Date	14-Apr-11	Job No.	FL1868.04
Attention	Mr. Thomas Lubozynski, P.E.		
Re:	Response to Request for Add'l Information Class I - Lateral Expansion Construction J.E.D. Solid Waste Mgmt. Facility Permit App No. SC49-0199726-017

**Subject: Response to Request for Additional Information dated 18 March 2011
J.E.D. Solid Waste Management Facility (WACS #89544)
Class I – Lateral Expansion Construction
Osceola County, Florida
(Permit Application No. SC49-0199726-017)**

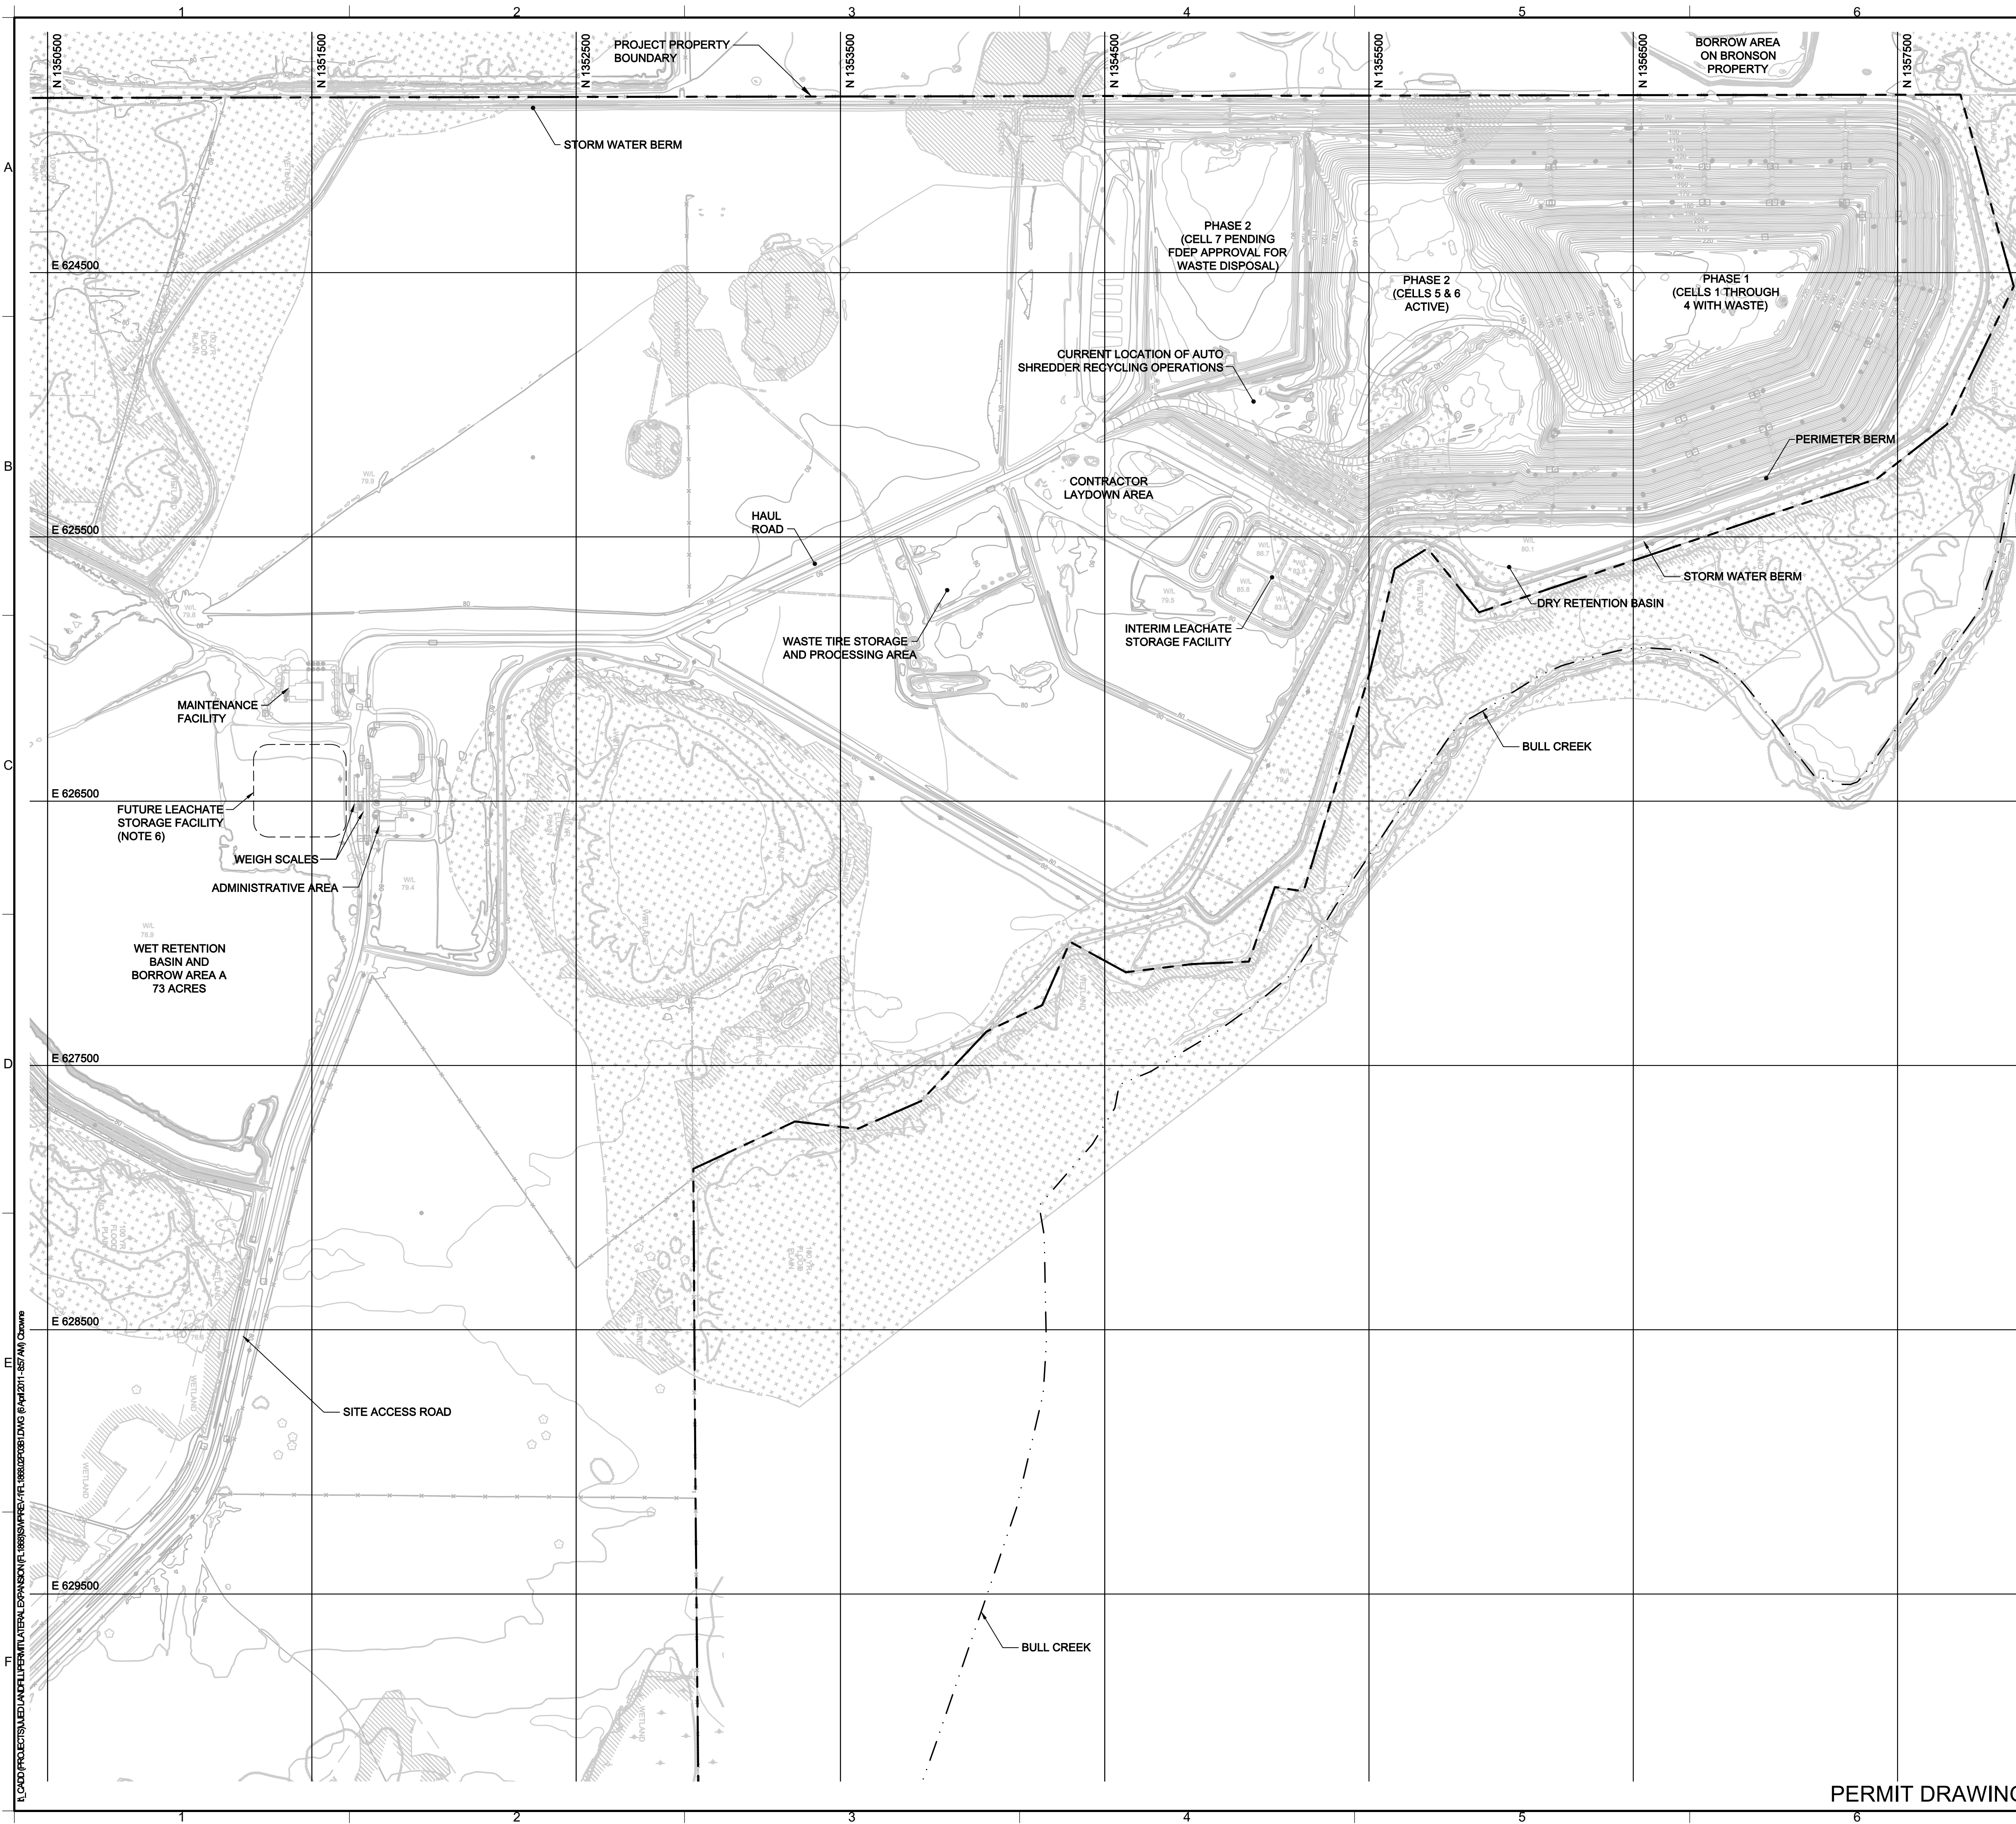
d. Changing the leachate management system

i. Eliminating the temporary leachate storage location

1. Item "a." refers to "previously approved Cells 11 through 23." The wording should be revised to "previously approved Cells 11 through 21" because Cells 22 and 23 have not yet been approved.
2. Item "d.i." refers to eliminating the temporary leachate storage location. It is anticipated that the currently permitted future leachate storage area (refer to Sheet 7 of the Vertical Expansion Permit Drawings, dated September 2007) will be constructed as previously approved. However, this will be a temporary rather than permanent facility as it will ultimately be removed after the permanent leachate storage facility is constructed in the location shown on Sheet 7 of the Lateral Expansion Permit Drawings, dated February 2011. To further clarify, Sheet 3B of the Lateral Expansion

Permit Drawings has been revised with a callout and note to describe the future leachate storage locations. Sheet 3B is included in **Attachment 1**.

- FUTURE LEACHATE STORAGE FACILITY IS THE FACILITY DEPICTED ON SHEET 7 OF THE VERTICAL EXPANSION PERMIT DRAWINGS (SEPTEMBER 2007). RELATIVE TO THE LATERAL EXPANSION CONSTRUCTION, THIS WILL BE A TEMPORARY LEACHATE STORAGE FACILITY. THE FINAL PROPOSED LOCATION FOR THE LEACHATE STORAGE FACILITY IS DEPICTED ON SHEET 7 OF THIS LATERAL EXPANSION PERMIT DRAWING SET.

TITLE: **SITE DEVELOPMENT PLAN**

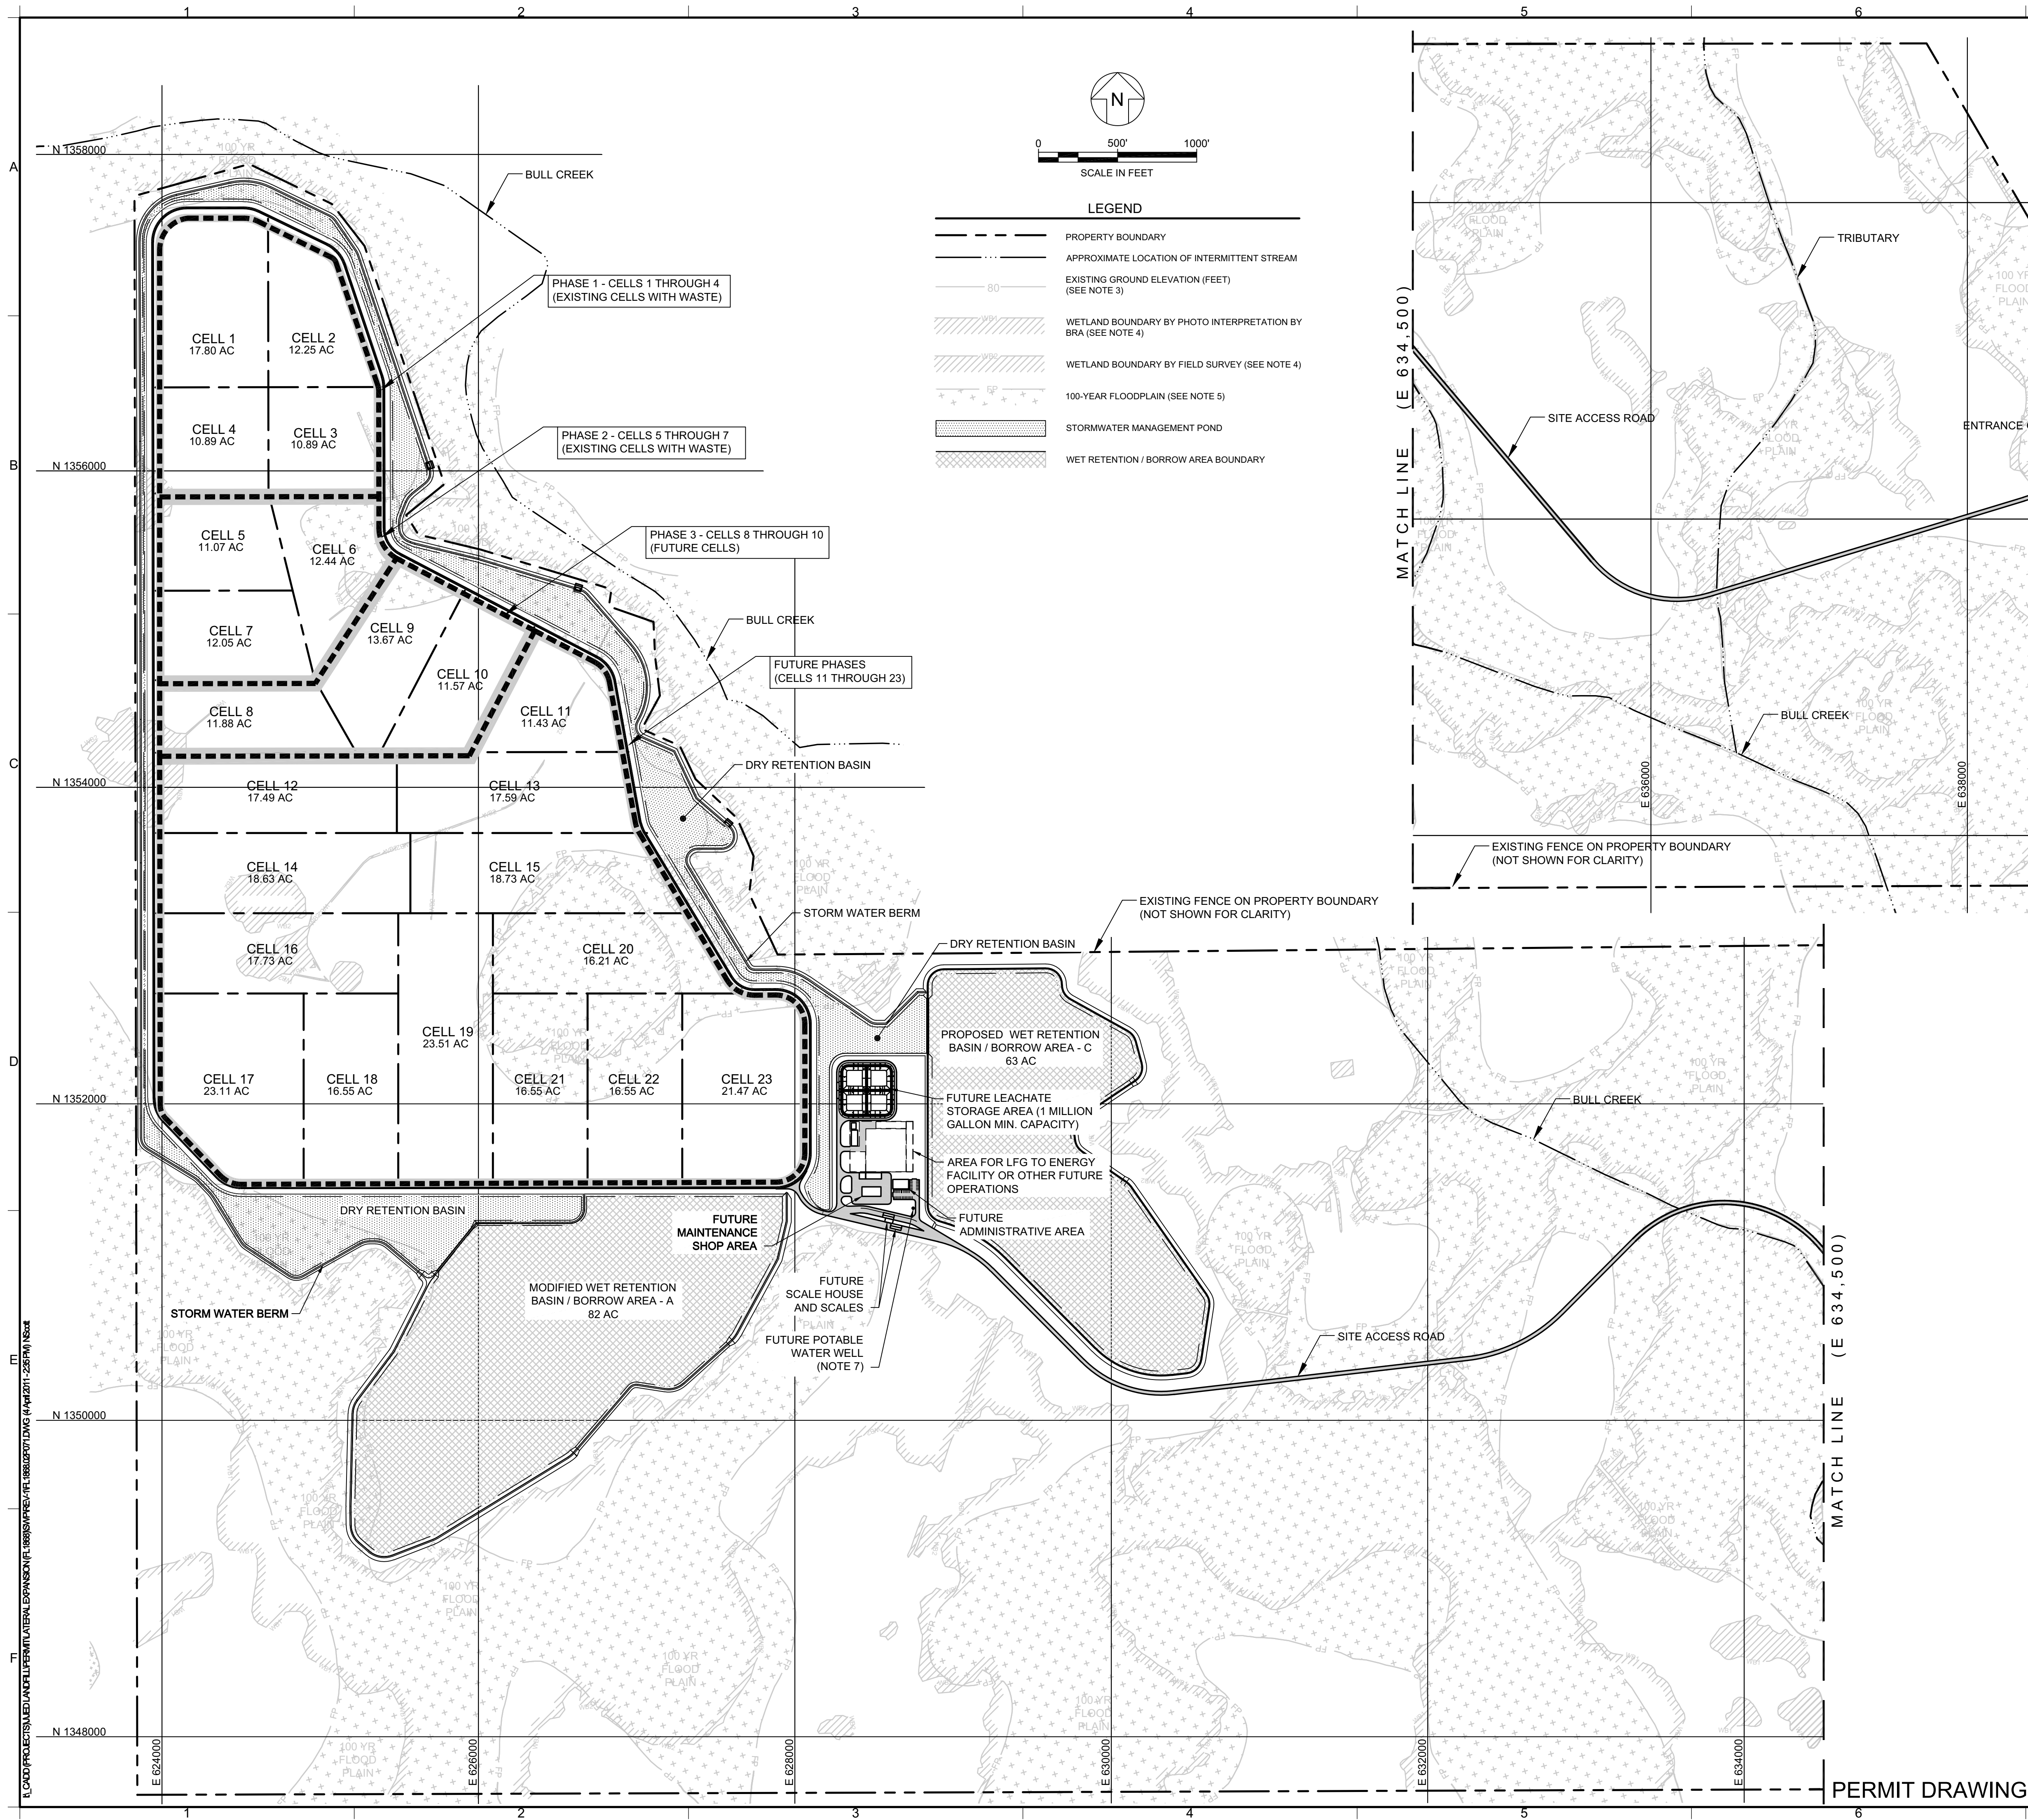
12. Rule 62-701.300(2)(b), F.A.C. requires that no waste be placed within 500 feet of existing or approved potable water well. Part C of the application refers to Section 2.2 for the information. Appendix C Sections 2.2.5 and 4.7 notes the well survey, which includes the on-site well. Figure 5 shows the well location and Table 12 notes that the well is potable.

The well is within 500 feet of proposed waste disposal. The Department does not see any plans for addressing this prohibition (e.g. set-backs, abandonment, etc.) Please discuss and include expected timeframe for the plans.

Omni will decommission the existing on-site potable water well prior to placement of waste within 500 feet of this existing well. At that time, a new (replacement) well will be constructed at least 500 feet away from the proposed waste disposal limits south of the future administrative area as shown on Drawing 7 (See **Attachment 1**). Based on the geometry of the proposed cells

- THE CELL ACREAGES ON THIS SHEET CORRESPOND TO THE LINED AREA AS MEASURED TO THE EDGE OF LINER MARKER (SEE DETAIL ON SHEET 15).
 - FUTURE POTABLE WATER WELL TO BE CONSTRUCTED PRIOR TO PLACEMENT OF WASTE IN CELL 19.
